Holiday Inn Express

1748 Taft Street, Hollywood, FL

Proj. No. 19-23

Alexandra Guerrero, Principal Planner (aguerrero@hollywoodfl.org) 954-921-3471

LANDSCAPE PLAN

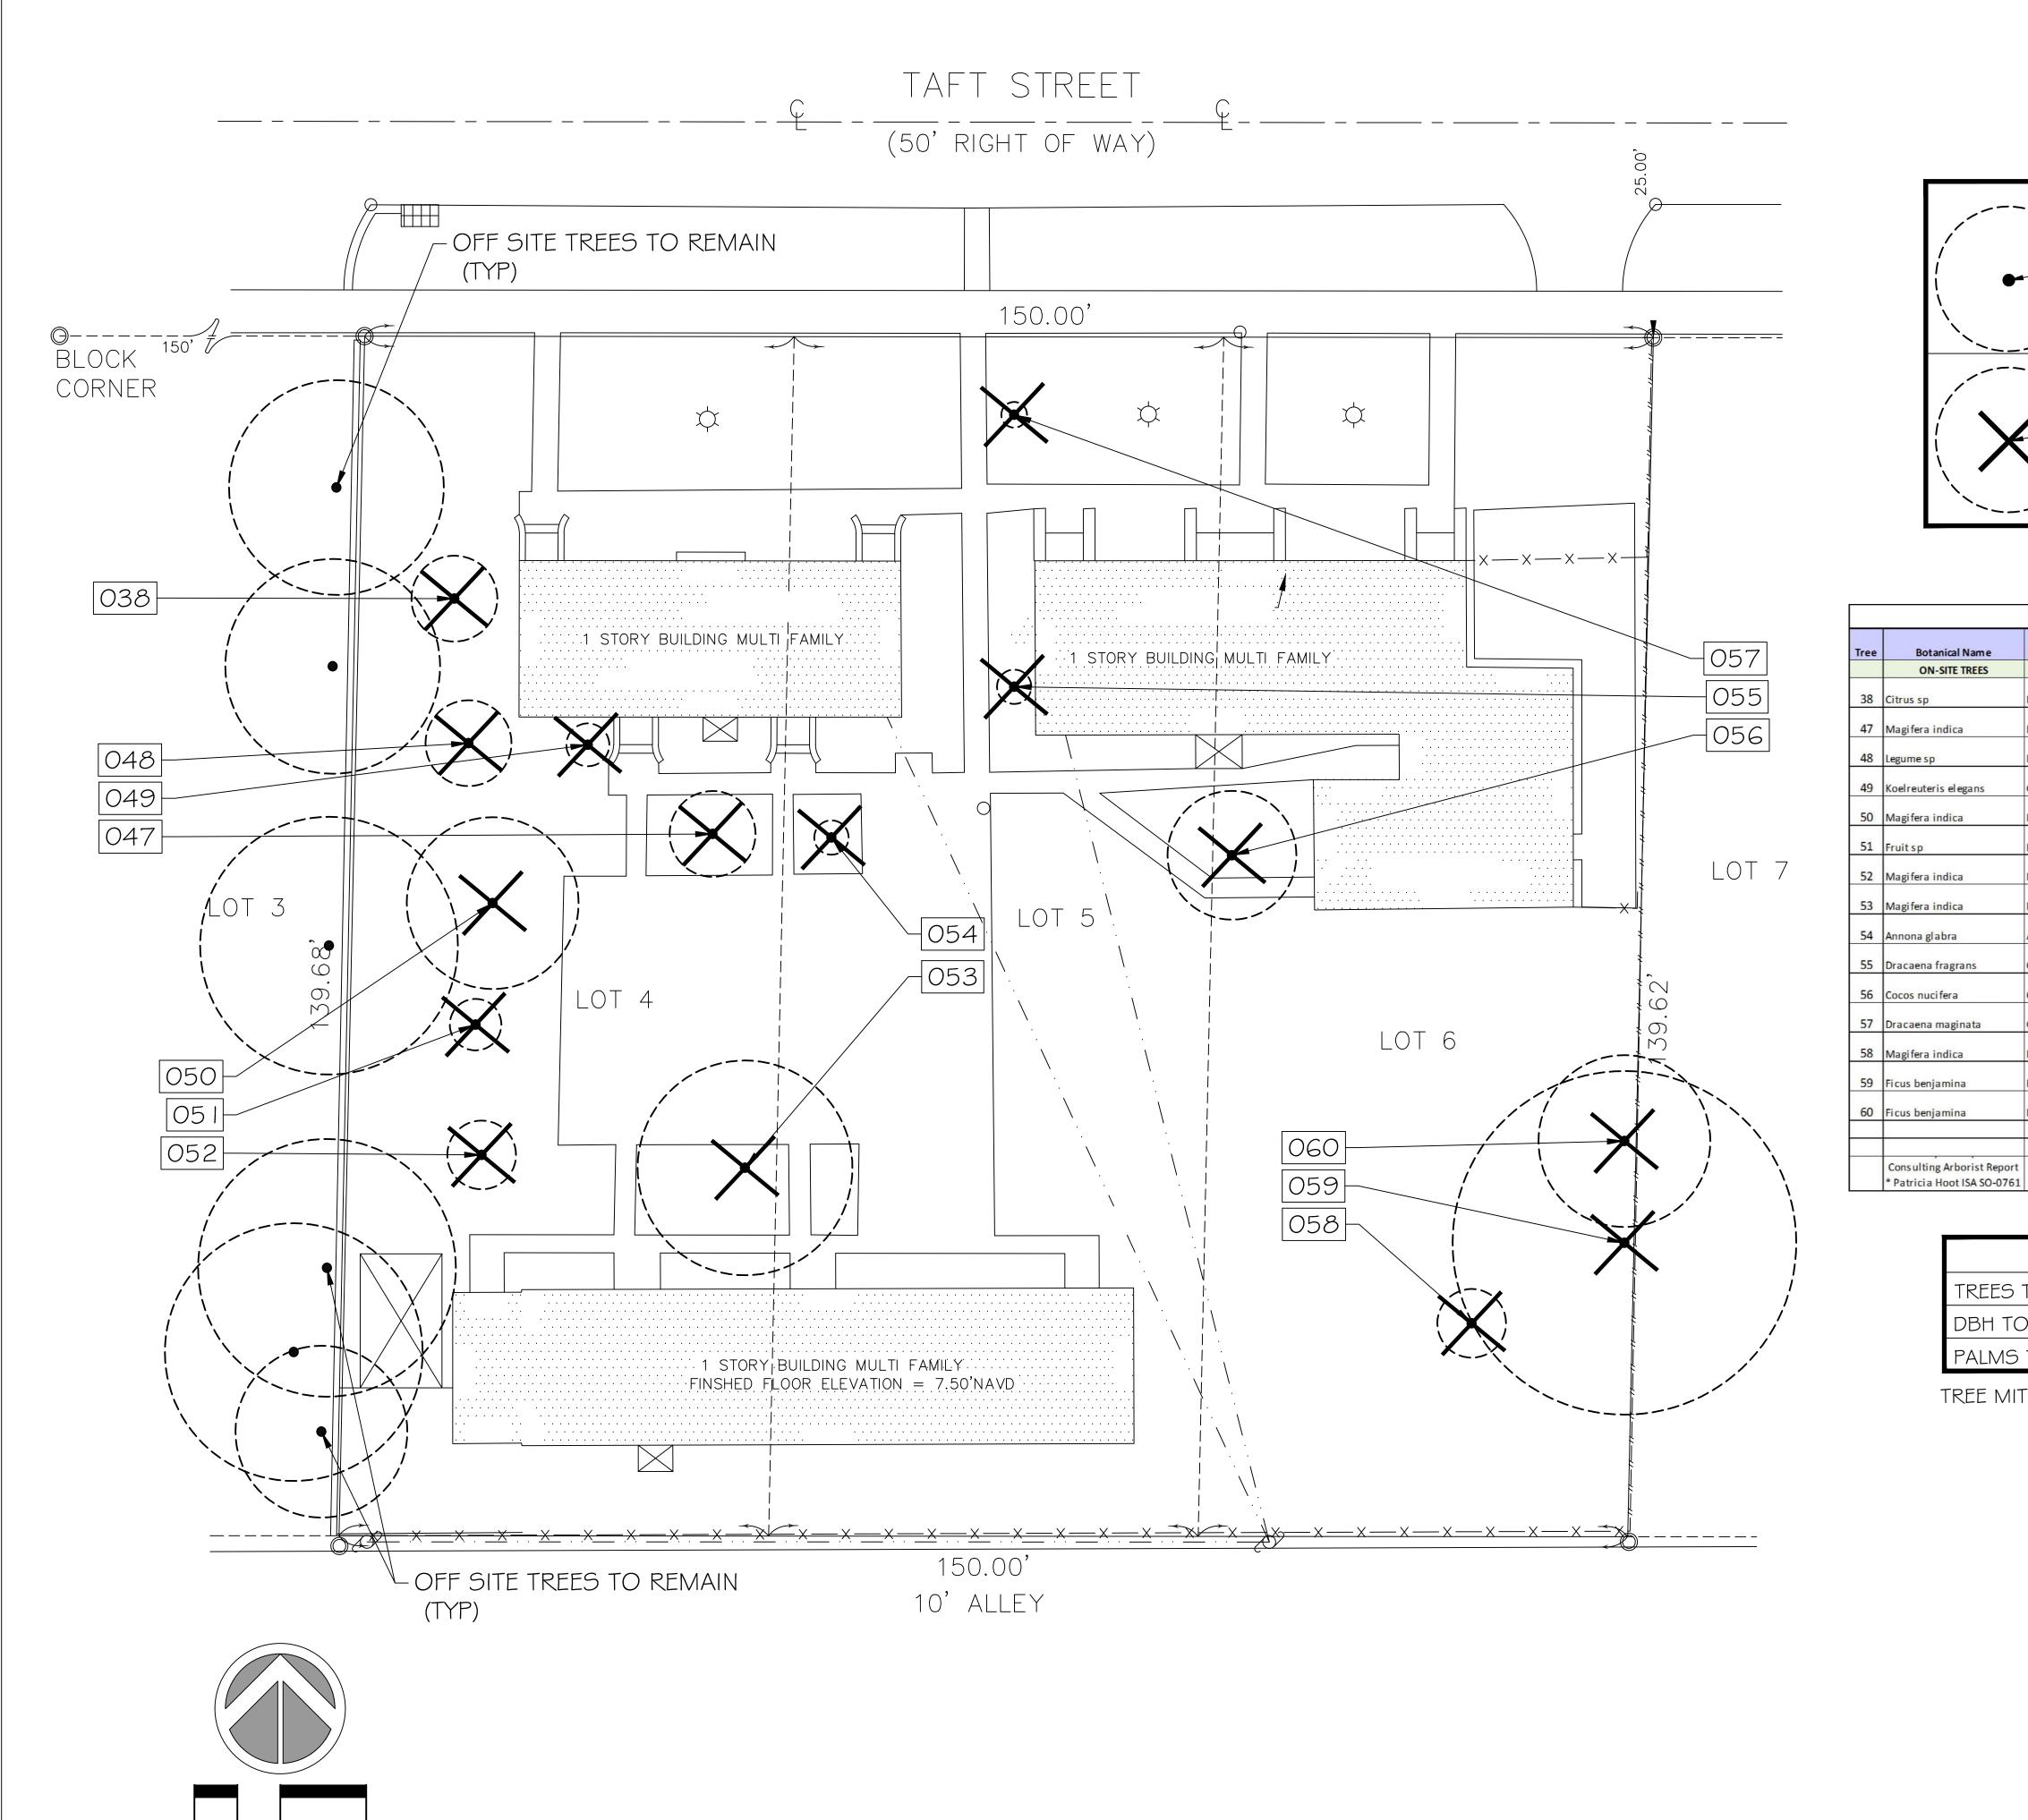
13. Replace some of the palms with pigeon plum trees (*Coccoloba diversifolia*). They require much less fertilizer and are not susceptible to the palm diseases that are spreading in South Florida.

Response: The Carpentaria palms at the NE corner of the site have been replaced with two Pigeon Plums as requested.

Sheet Title
TREE
DISPOSITION
PLAN
Revision Dates

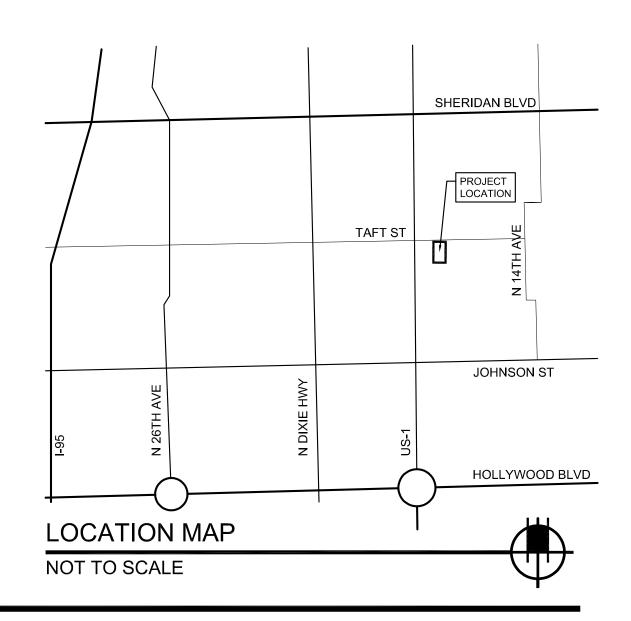
1. As per provided tree survey convert all trees on site listed on survey to inches and provide a tree disposition plan and landscape plan by a registered professional licensed Landscape Architect in the State of Florida that compliments the building architecture and uses, provides for shade, beautifies the site, accentuates site features, and serves as a buffer where appropriate. Provide tabular data chart on plan that identifies City of Hollywood landscape requirements and how they are being met for Perimeter landscape, Species diversity requirements, Interior landscape for at grade parking lots and vehicular use areas, open space, view triangle, utility lines, lot dimensions, center line and monument line and comply with all planning and development board and historic preservation board requirements and irrigation plans. Landscape plan should comply with all the requirements according to City of Hollywood Landscape manual, chapter 155.52, Article 9 LDR and section 6 landscape Plan details and specifications for technical review process. Landscape plan set to include and clarify what is been provided as per city code requirements for landscape for project type and minimum percentage of landscape required and what is provided for tree mitigation if any. Mitigation for trees is inch by inch for hardwoods and 1:1 for all palm tree species with replacement species approved by the city of Hollywood. As per provided only LP-1 landscape plan was provided and a tree disposition plan was not included. Provide a revised LP-1 and new tree disposition plan with all existing trees on site with disposition and clear calculation for both tree mitigation for trees proposed to be removed and code required trees. Any deficiency in tree mitigation unable to be planted on site to be clearly shown on plans and explain how many inches will be compensated via tree trust fund contribution or on site. Clearly provide monetary contribution on tree mitigation data table with a dollar amount value for tree trust fund contribution.

Response: A Tree Disposition Plan has been provided showing all existing trees with tabular data chart....the Landscape Plan has been revised to reflect as such. Tree Mitigation will be coordinated with staff, as the majority of the existing trees are fruit trees, and can not be relocated on site, per Code.

FIRST FLOOR PLAN

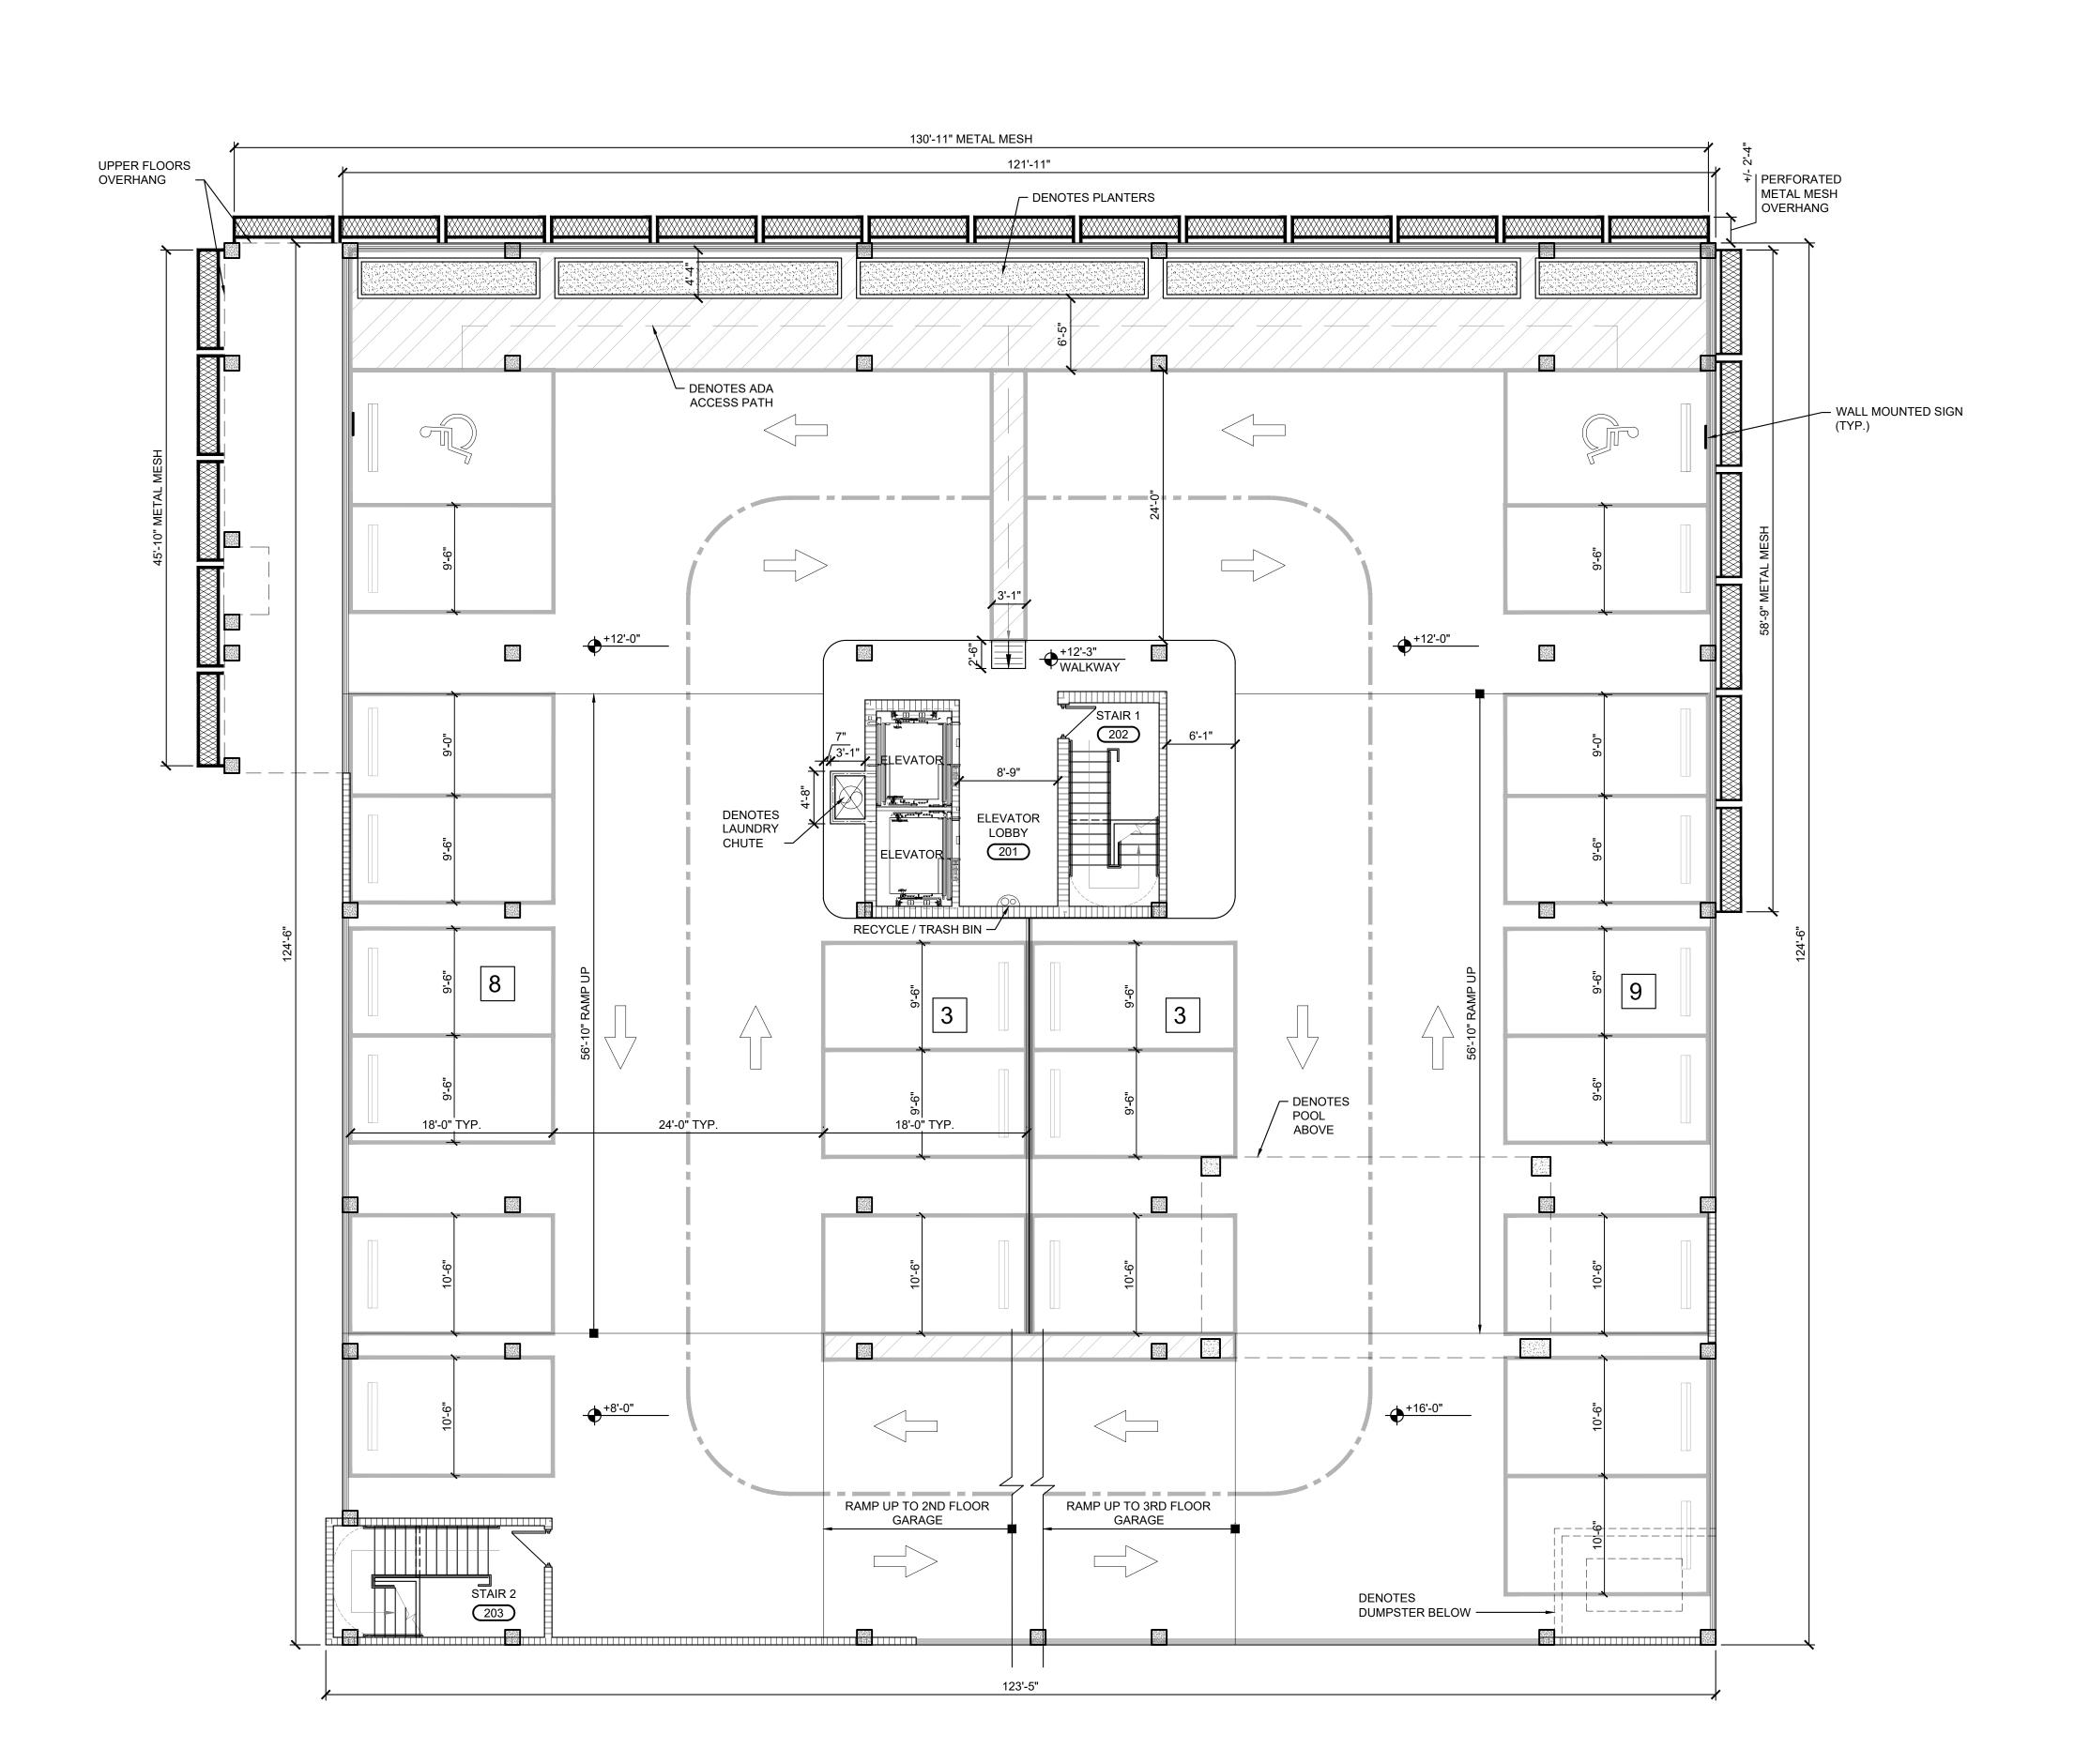
2. Provide Site Data on Site Plan sheet, not the cover page.

4. Provide an updated FAR breakdown. A breakdown of each floor shall be provided. All vertical circulation shall be counted towards FAR; i.e. elevators, stairs.

8. On Sheet A121, what is the room on the right-hand corner near the drive entrance for? Not labeled.

1. Ensure that all plumbing, mechanical and electrical fixtures and equipment are indicated on Site Plan and Elevations. If visible from any right-of-way, provide screening.

1. Include note on Site Plan stating the maximum foot-candle level at all property lines (maximum 0.5 allowed).

1. As per the *Green Building Ordinance*, the project will require a third-party *Green Building Certification*. Include this on the site plan.

2. Indicate on the site plan where the infrastructure necessary for an electric vehicle-charging station will be located.

7. Ensure that the dumpster space also accommodates a recycling bin. Indicate its location on the site plan.

Show on plans how ADA accessibility requirements are met. ADA accessible route is required between accessibility parking and building access as well as accessible route to the public rights-of-way.

4. A Knox box will be required at the main entrance. Please show on the next submittal.

Response: Site data moved to Sheet A-121.

Response: The FAR has been updated – see A-121.

Response: The room is for storage.

Response: All mechanical and electrical equipment will be screened as required by code – a note has been added to Sheet A121.

Response: A note regarding lighting-spillage has been added to Sheet A121.

Response: Acknowledged – a note has been added to the Sheet A121, as well as adding the Green consultant (Bravo) has been added to the Project Team.

Response: The locations for the charging stations (2) have been added to the lower level parking – see Sheet A-121.

Response: The plan for the dumpster area has been modified to accommodate recycling – see Sheet A-121.

Response: The accessible path from both the street and parking is depicted with arrows on Sheet A-121.

Response: See Sheet A-121 for the knox-box location (adjacent to the ADA entry).
